## QUALITY ASSURANCE -- NON-CONFORMANCE REPORT

**Report No:** NCR-000772

**Reference Description:** ZPMC performed weld removal of two SPCM welds without prior Engineer's approval or an approved CWR

**Dear:** Mr. Charles Kanapicki  
**Job Name:** SAS Superstructure

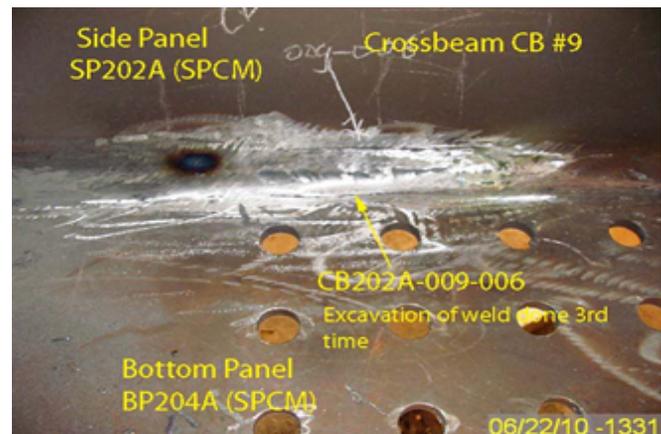
-ZPMC performed 3rd time excavation of Seismic Performance Critical Material (SPCM) welds identified as CB202A-009-018 & 006 without prior Engineer's approval or an approved Critical Weld Repair for this 3rd time repair.

-The welds are Complete Joint Penetration (CJP) joining the SPCM bottom panels to the SPCM side panels.

-The affected panels are identified as bottom panels BP205A and BP204A, Side panels SP202A and SP205A. All are identified as SPCM.

-These welds were previously removed and re-welded on 06/08/10 and 06/14/10 for the purpose of aligning the bottom panel of the crossbeam to the FL3 bottom panel of Orthotropic Box Girder (OBG) Segment 8AE.

-Welds are being excavated and welded today (6/22/10) for the repair of the rejectable Ultrasonic Testing (UT) indications discovered by ZPMC QC UT technicians.

ZPMC has written an internal NCR to address the requirement of CWR prior to start the welding repair. ABFJV QCM has met with ZPMC's QA manager to discuss this issue and has emphasized the requirement to the quality department. Refresh training has been performed to all the CWIs. ZPMC is providing the CWR & NDT records show the welds in question are acceptable. Based on this, ZPMC is requesting closure of this NCR.

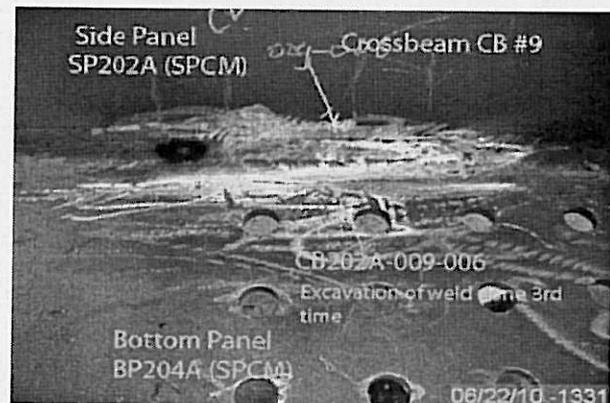
-ZPMC performed 3rd time excavation of Seismic Performance Critical Material (SPCM) welds identified as CB202A-009-018 & 006 without prior Engineer's approval or an approved Critical Weld Repair for this 3rd time repair.

-The welds are Complete Joint Penetration (CJP) joining the SPCM bottom panels to the SPCM side panels.

-The affected panels are identified as bottom panels BP205A and BP204A, Side panels SP202A and SP205A.

-These welds were previously removed and re-welded on 06/08/10 and 06/14/10 for the purpose of aligning the bottom panel of the crossbeam to the FL3 bottom panel of Orthotropic Box Girder (OBG) Segment 8AE.

-Welds are being excavated and welded today (6/22/10) for the repair of the rejectable Ultrasonic Testing (UT) indications discovered by ZPMC QC UT technicians.

The Department accepted CWR detailing methods used to perform repair work, and the Contractor has supplied NDT reports verifying the repairs in question conform with Contract weld quality requirements. An internal NCR was also issued by the Contractor in regards to this issue.

Draft of Welding Discontinuity:

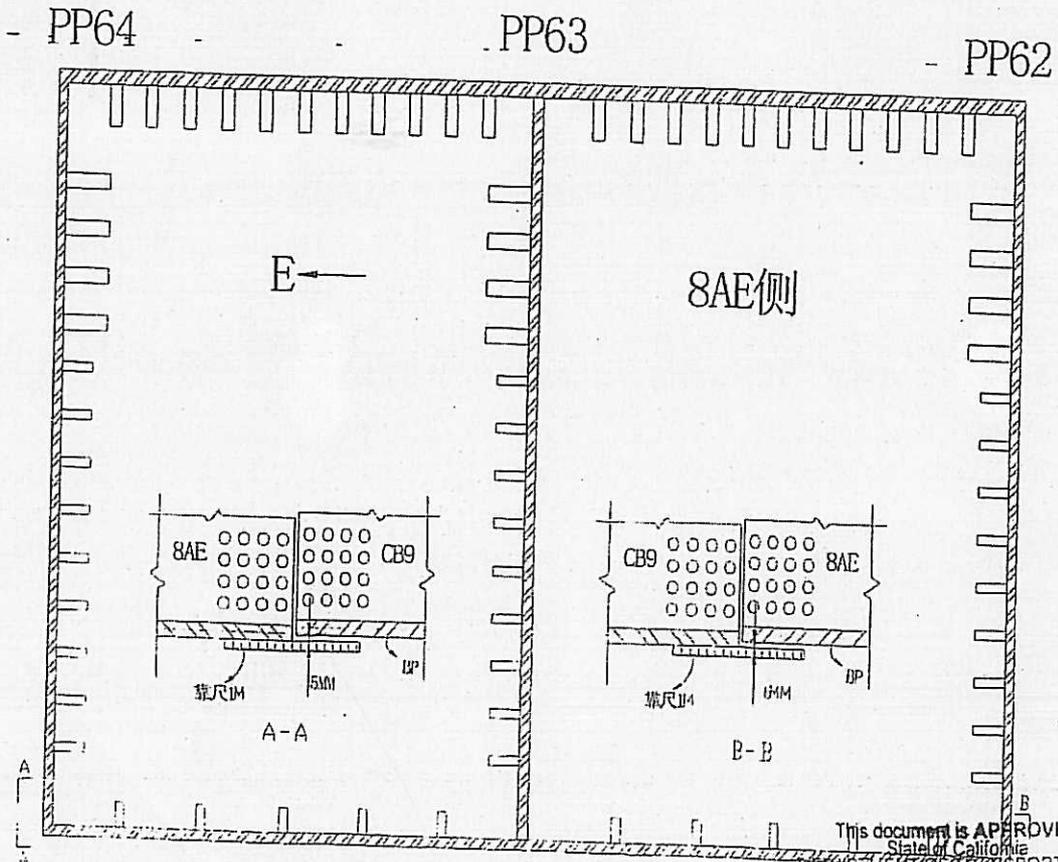
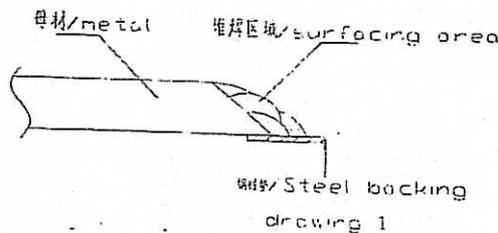
After inspection: the misalignment was found at 8AE and CB9 at PP62,PP64 after repair according to B-WR13530, the detail position and data sees the following draft, the gap was 7-8 mm after gouging, relevant weld ID: CB202A-009-018/006

1. 焊接变形和制作误差;
  2. 工人操作失误, 导致母材损伤.
1. Weld distortion and fabricate error;
  2. Worker operated error caused base metal gouged.

1. QC and CWI should be present to witness the repair, direct and supervise all repair operations during this repair to ensure the repair is per the disposition requirements, and the AWS D1.5 code requirements.
2. Prepare the joint according to the approved WPS and add steel backing according to the attached drawing 1.
3. Notify QA verbally prior to NDT. Perform 100%VT of the repair area.
4. Remove all defects by grinding to ensure all defects are completely removed if defects exist, and repeat "step 3" to assure complete removal of all defects if necessary.
5. Preheat and weld according to the approved WPS to ensure the gap meet requirement.
6. Remove steel backing after welding and grind the weld flush.
7. Notify QA verbally prior NDT. Perform relevant NDT (UT, MT and VT) to the repair area.
